Service Bulletin

Ref. No. **COM-0218 (B056)**

Subject	Note when releasing the paper jam/maintaining the machine (Prohibition of use of the flammable sprays and liquids)
Model	All models

[Change 2 Avoiding the contact with the staple unit that is at the new migrating position]

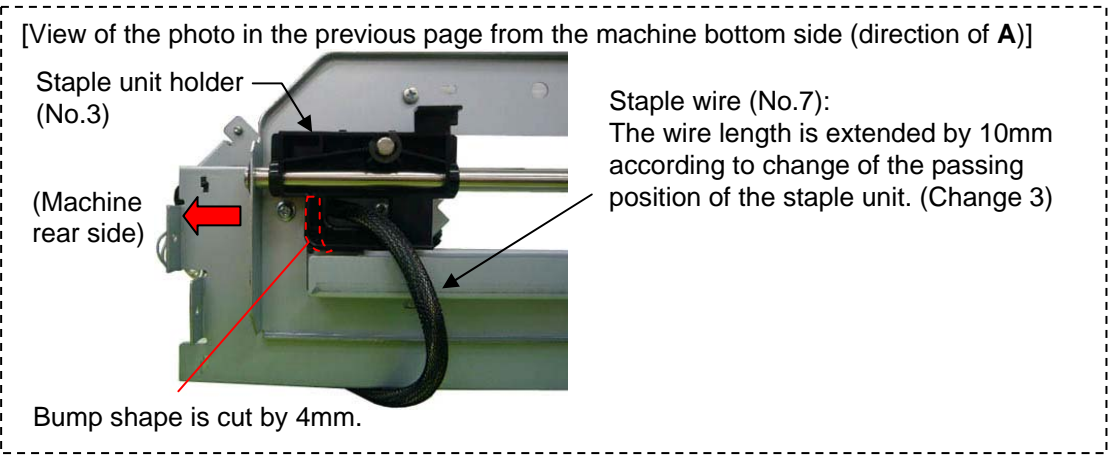
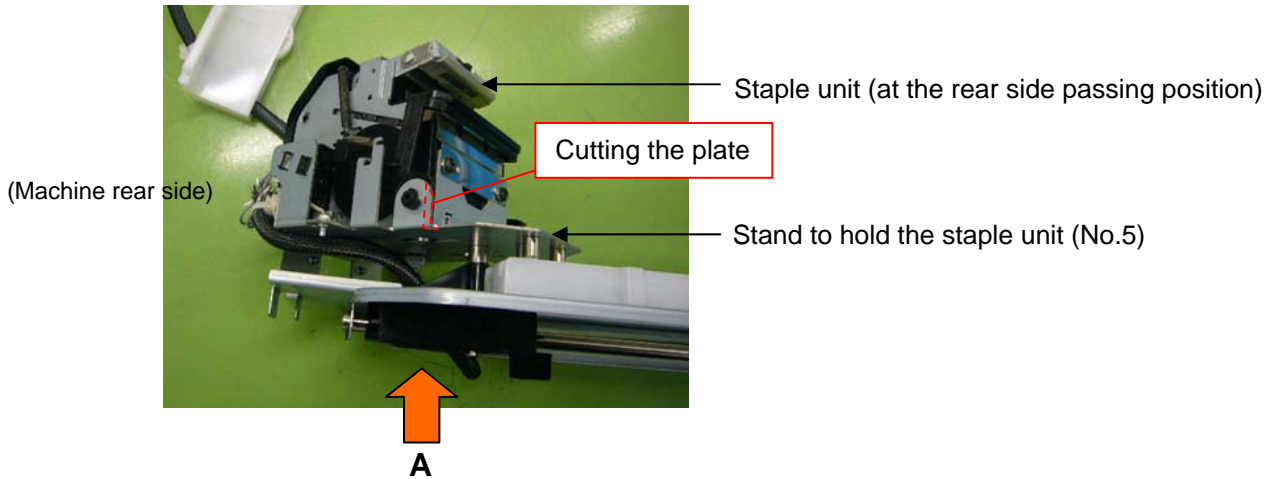
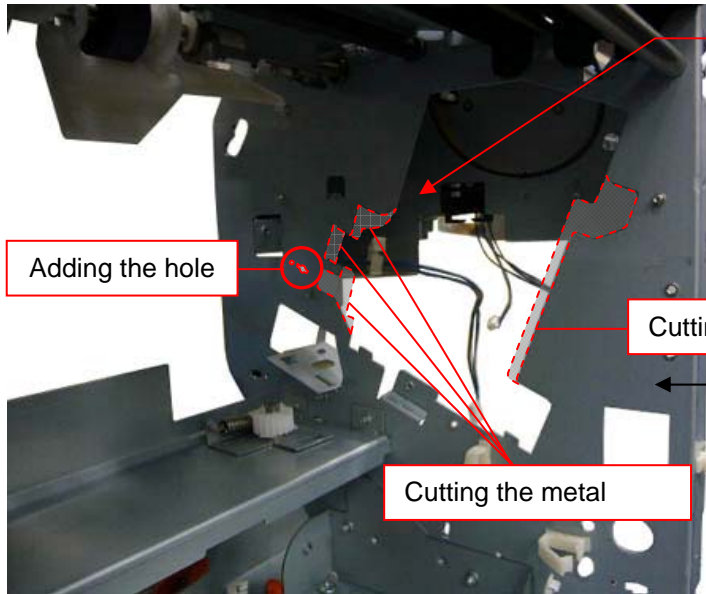
<Staple unit slide section at the machine rear side> (Below is the old shape)

<Slide section of the staple unit at the machine rear side>
(Below is the new rear frame.)

Cutting the metal

New rear frame
(It is not supplied in the field)
: - The hole for migrating the staple unit is expanded. (Change 2)
- The hole for fitting the RDHS wire alignment part (No.9) is added. (Change 3)

(Photo in below is the fitting side to the fan mounting plate of the cooling fan)

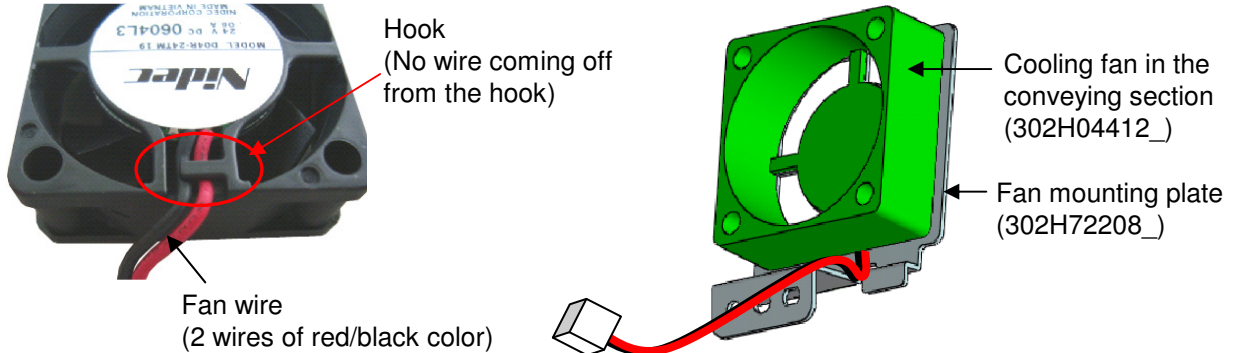
- 2) Check if the fan wire passes through the cut-out of the conveying base when refitting the assembly of the cooling fan to the conveying base.

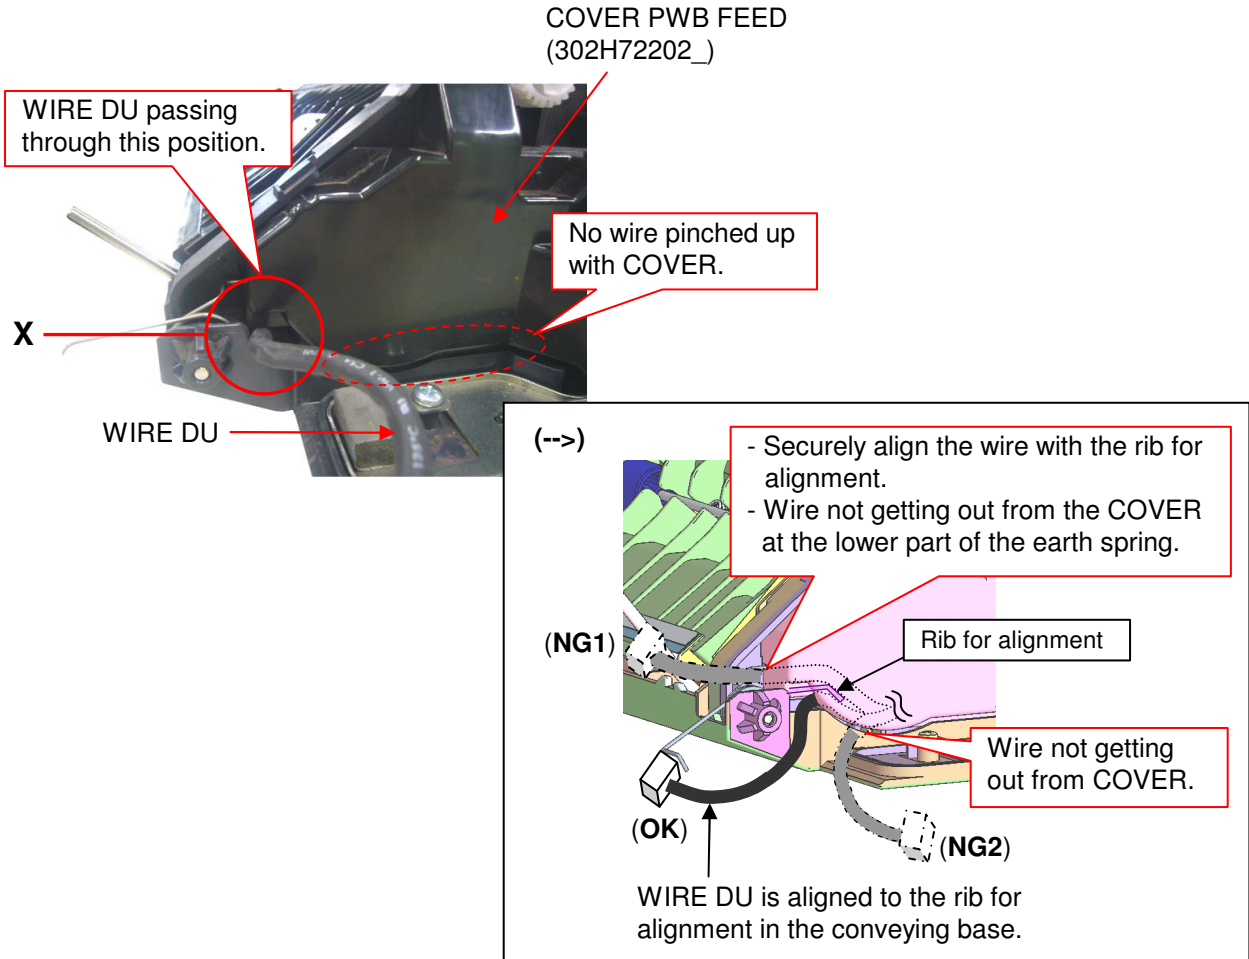
3) (-->) When reassembling the conveying unit, check if WIRE DU is passed through the position marked **X** in the figure below when refitting COVER PWB FEED to the machine rear side of the conveying unit.

<State with the fuser guide adding the rib (Cross-section view)>
(After)

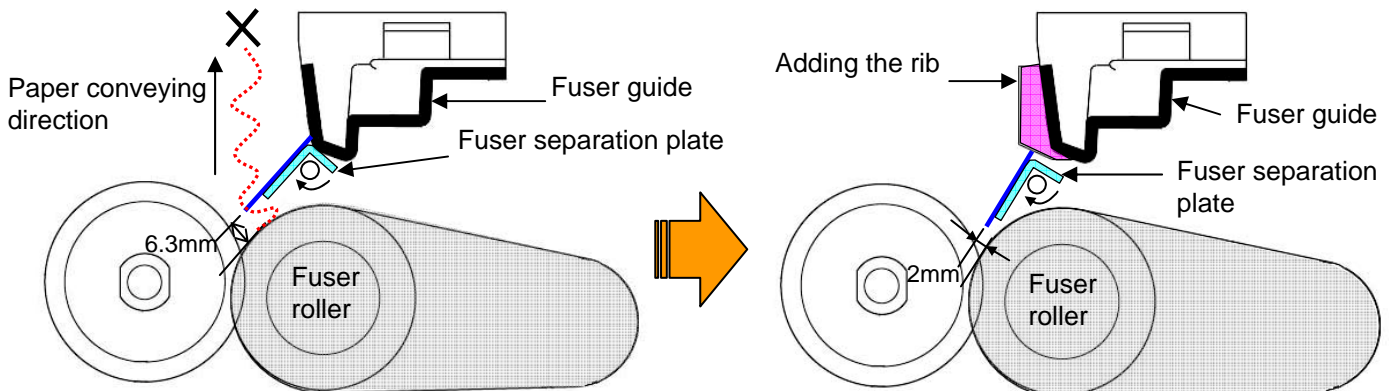
2) 2 ribs are added to the guide of the fuser unit to limit the movable range of the fuser separation plate to prevent the paper from wrapping around the fuser roller when the jam occurs.

<State with the old fuser guide (Cross-section view)>
(Before)

(-->) Please confirm that there are the gap between the fuser separation plate and the fuser guide after fitting the new fuser guide (No.13). And in case there is no gap, please add the washer (No.14). (Please refer to the detail in the page 6.)

<Common use of the parts (Secondary transfer guide)>

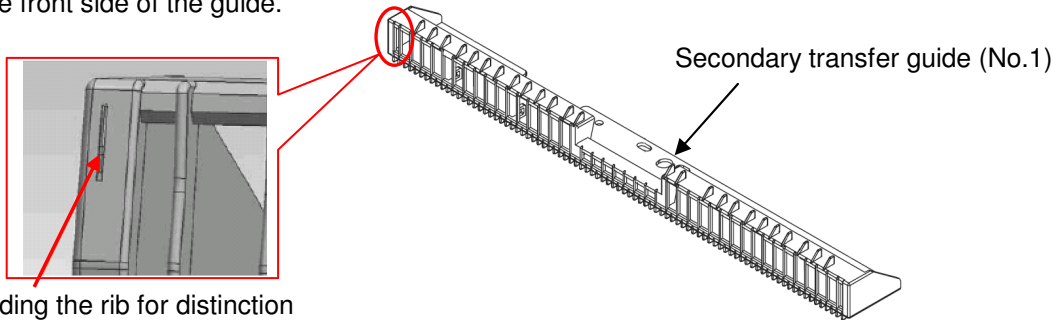
The rib on the secondary transfer guide (No.1) is thickened for common use of the parts. The parts number remains unchanged according to this change. However, the rib for distinction is added to the machine front side of the guide.

<Change of the power cord caution label --> After using up the old stock>

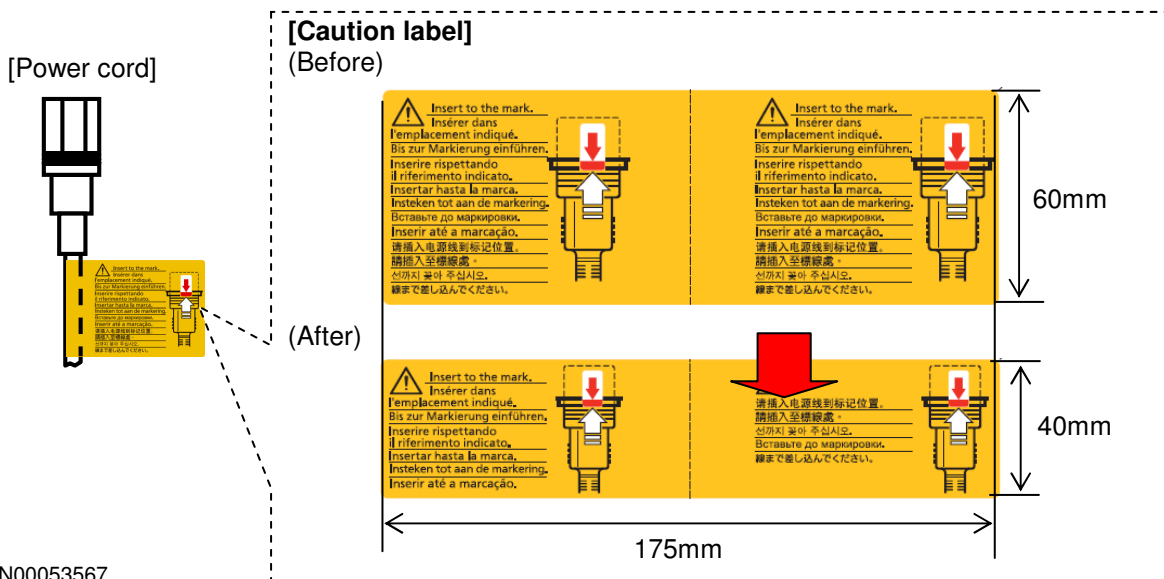
For improving the assembly process, the caution label affixed to the power cord is changed as below. The parts number remains unchanged according to this change.

- 1) Change of the size. (Height: 60mm --> 40mm)
- 2) Relocation of the caution contents according to the above change. (Contents remain unchanged.)

Change of the caution label directing the set direction of originals on the DP

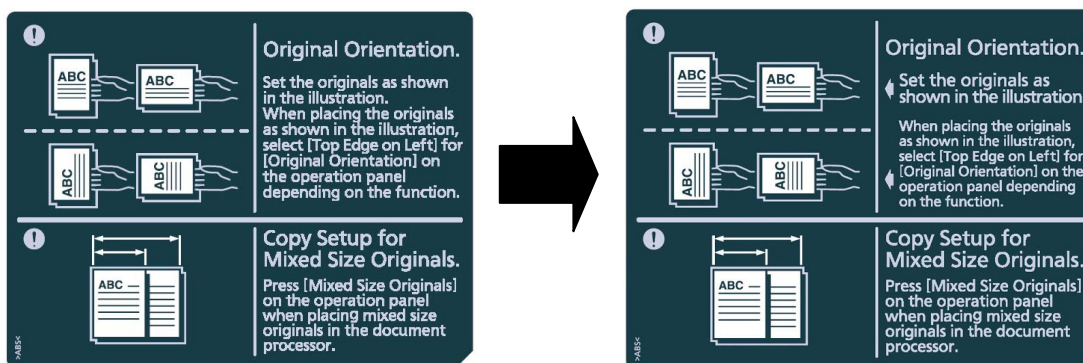
Positions of the illustration and the description on the caution label directing the set direction of originals on the DP (No.1 thru 3) is vertically shifted.

Therefore, the size and position of characters in the description is changed and arrows indicating the corresponding illustration are added.

<Bk developer unit for preventing the toner smudge>

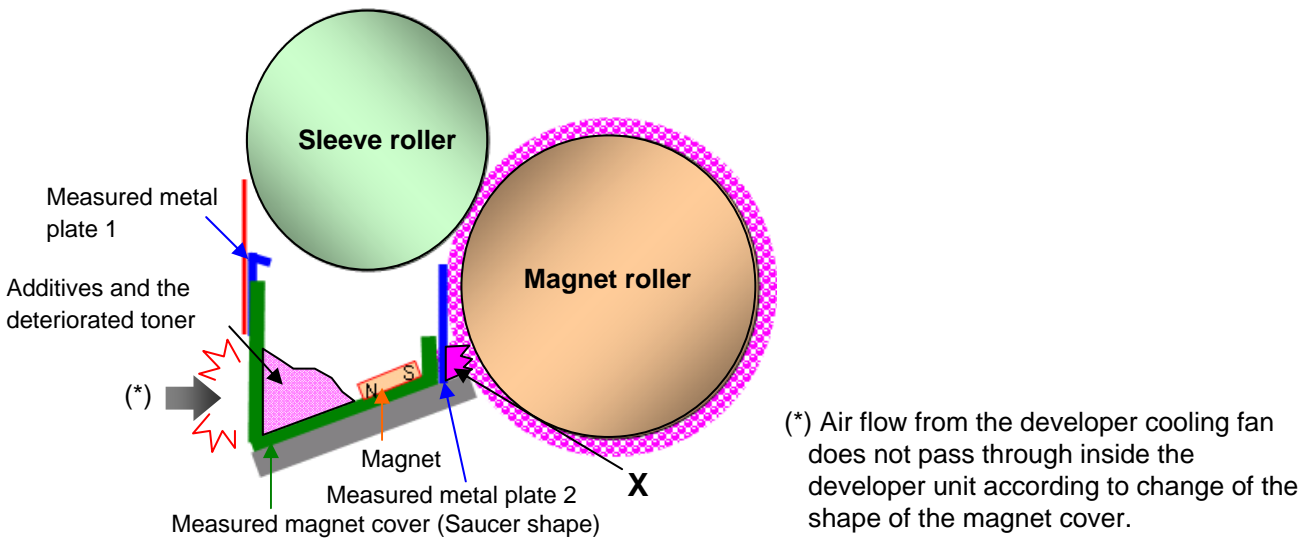
- Magnet: Adding the magnets to the both ends of the magnet cover to collect the deteriorated toner as the grain ear shape (X in the figure below) over the measured metal plate 2 so that that deteriorated toner shuts the gap between the magnet cover and the magnet roller to prevent the toner scatter from the gap.
- Measured metal plate 2: Planting the measured metal plate 2 in the front of the magnet roller to prevent the deteriorated toner scatter that is collected in the measured magnet cover for the magnet roller.

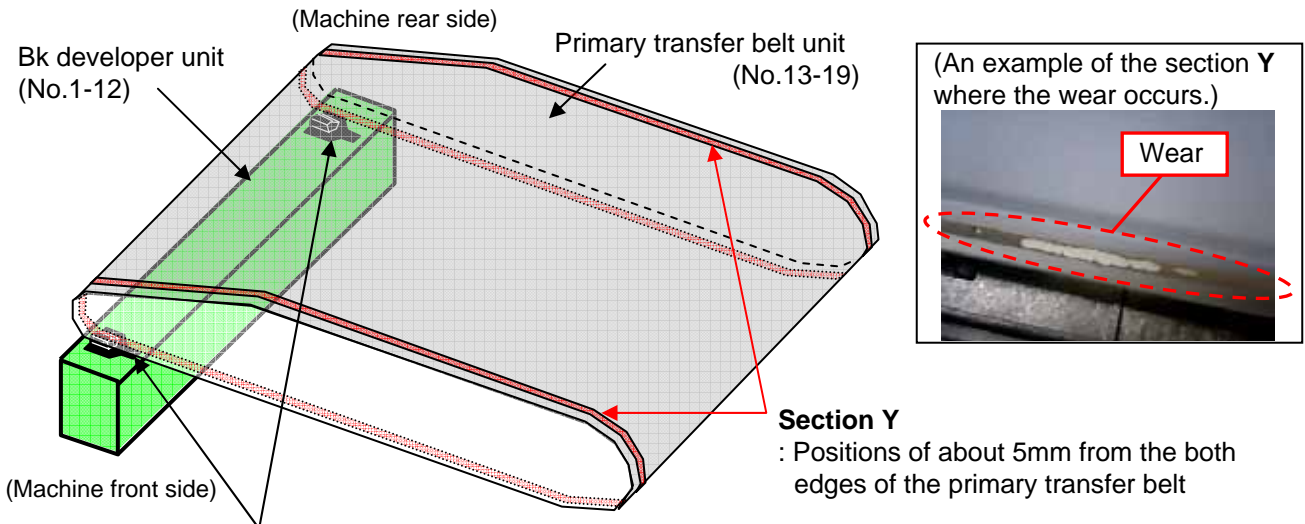
Material of the seal (X: No.20) on the topside of the Bk developer unit is changed to the one with lower friction resistance than before to reduce the wear of the section Y of the primary transfer belt.

Material of the seal: (Before) Seal planted nylon fiber (Black) --> (After) Fujiron (Teflon felt) (Dark brown)

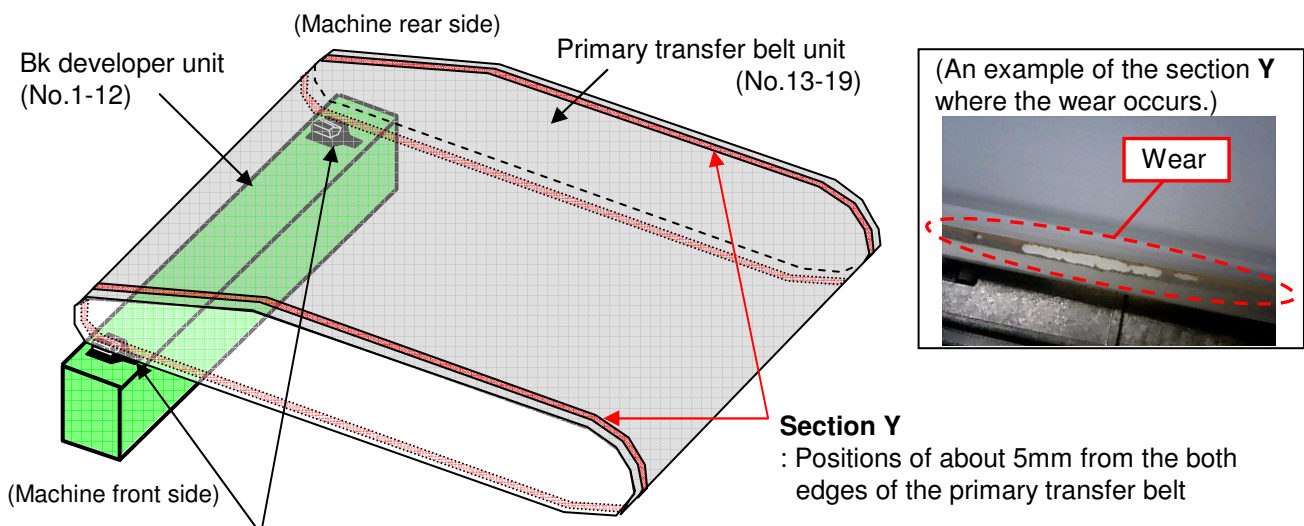
Material of the seal (X: No.20) on the topside of the Bk developer unit is changed to the one with lower friction resistance than before to reduce the wear of the section Y of the primary transfer belt.

Material of the seal: (Before) Seal planted nylon fiber (Black) --> (After) Fujiron (Teflon felt) (Dark brown)

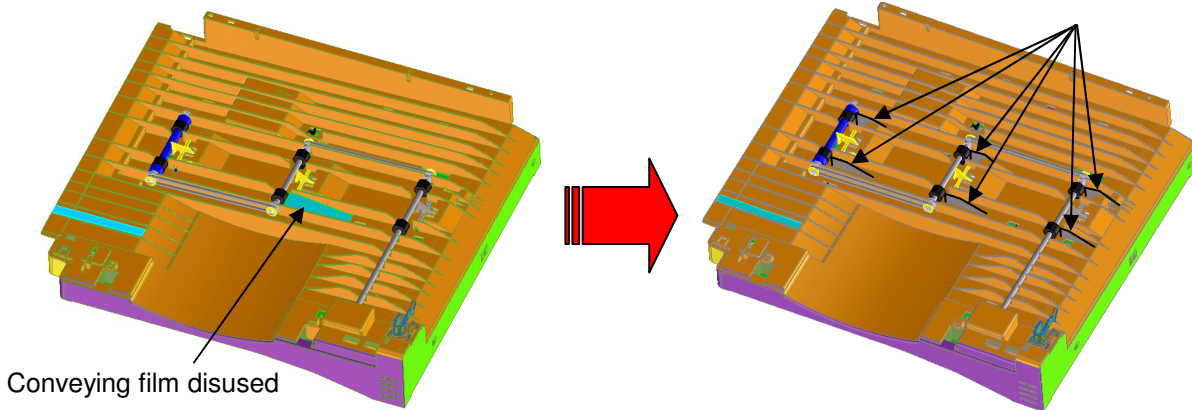
6 points of conveying ribs are added to the lower guide (*) of the bridge unit (AK-470) and the conveying film (*) is disused that is affixed before the center conveying roller in order to improve assembly process.

<PARTS UNIT LOW VOLTAGE 200 SP(No.1)>

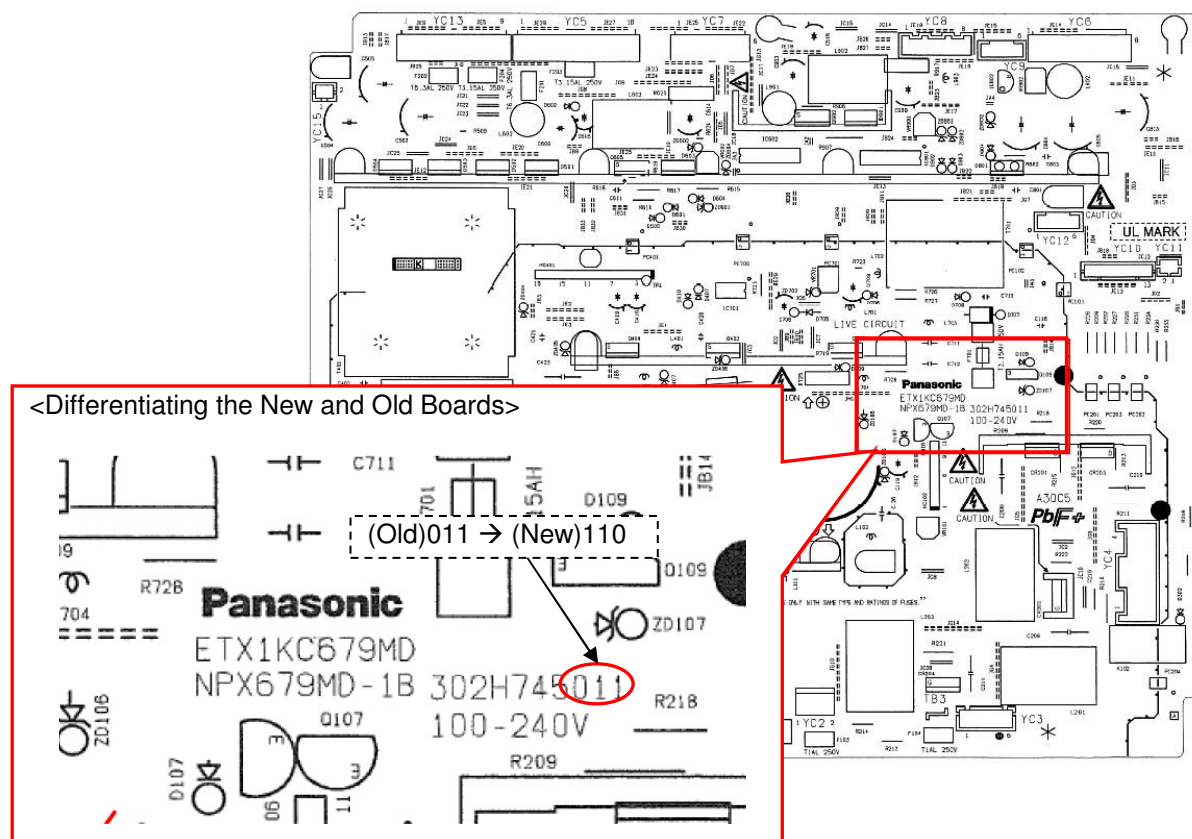
1) In order to increase the margin for the Zero Cross Pulse, the resistance of Board(No.1) has been changed from 100kΩ to 12kΩ.

FIG. 63 CLEANER-ASM

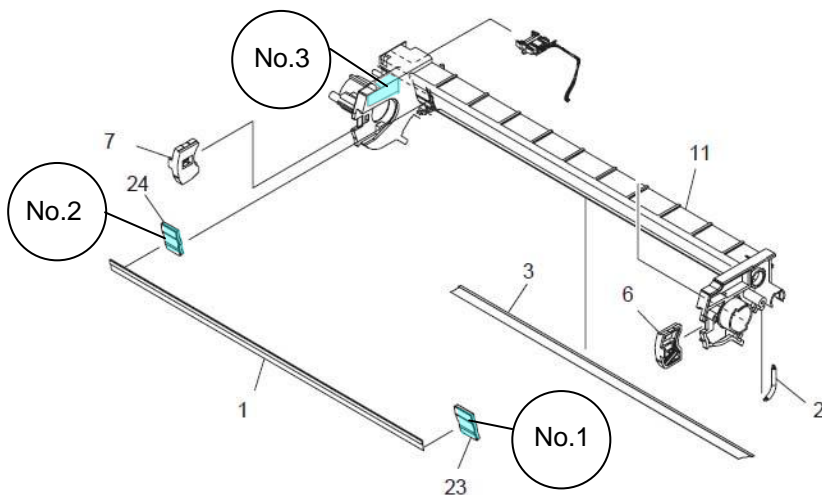
The following parts (No.1 to 3) for the drum cleaning unit are changed for common use. The film (No.3) that is not for field supply is set up for the service parts this time.

BF-730

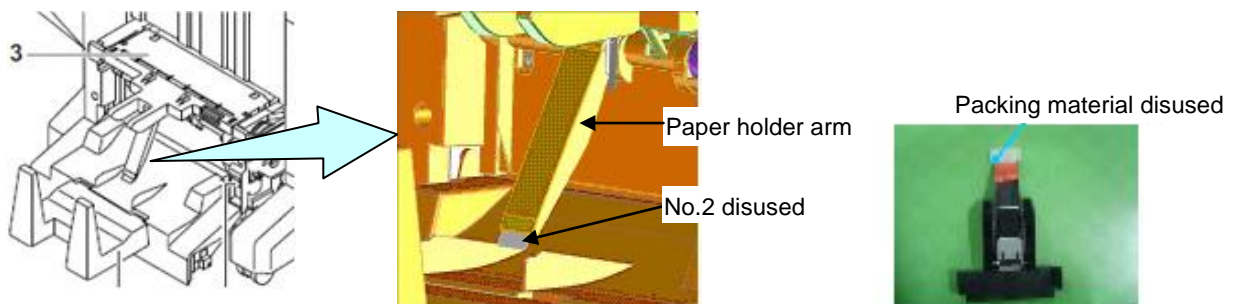
The film at the paper holder arm section turns to be unnecessary after the performance check and it is disused. Accordingly, the packing material for protection of the film in transit is also disused.
